## 9-1 – 12

### 901.1, 905.1

**Proponent:** Kim Paarlberg, International Code Council

### 903.5, Figure 903

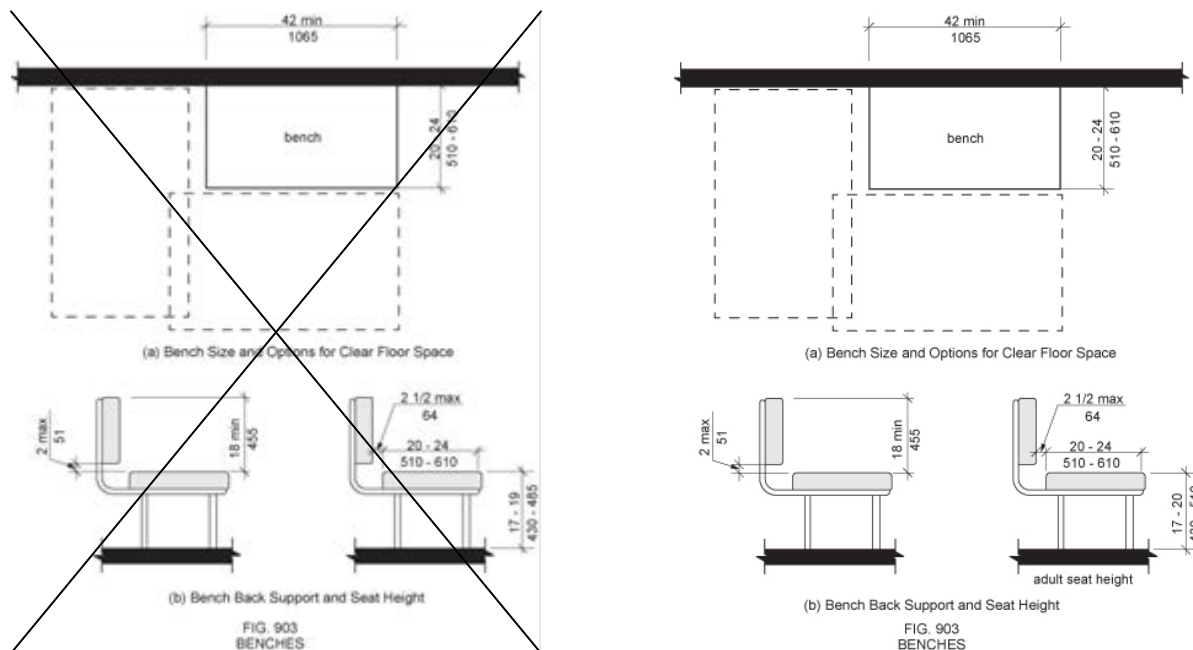
**903.5 Height.** The top of the bench seat shall be 17 inches (430 mm) minimum and ~~19~~ 20 inches (485 510 mm) maximum above the floor, measured to the top of the seat.

Increasing the maximum seat height to 20 inches (510 mm) would allow 75% of female manual wheelchair and 53% of male manual wheelchair users (D'Souza and Steinfeld, 2011, pg. 5) to transfer comfortably. Comfort in this case is determined by how closely the height of the transfer surface matches the height of a wheelchair seat. Steinfeld, et. Al., 2010 (pg. 85) report that "keeping the height of a transfer surface close to the height of a wheelchair seat reduces the effort necessary to transfer and provides a safer environment."

However, a fixed seat any higher than 20 inches (510 mm) would likely disadvantage people of short stature, particularly if it was the *only* seat. Encouraging innovation would help to accommodate a greater number of wheeled mobility users without disadvantaging people of short stature. Adjustability is the best option to accommodate the widest population but in the meantime, the upper limit should be raised to 20 inches (Steinfeld, et al., 2010, pgs. 85-86).

NOTE: This change necessitates a change to Fig. 903 to ensure consistency. Thus, the proposed revised figure has been attached, along with the existing figure for comparison purposes.
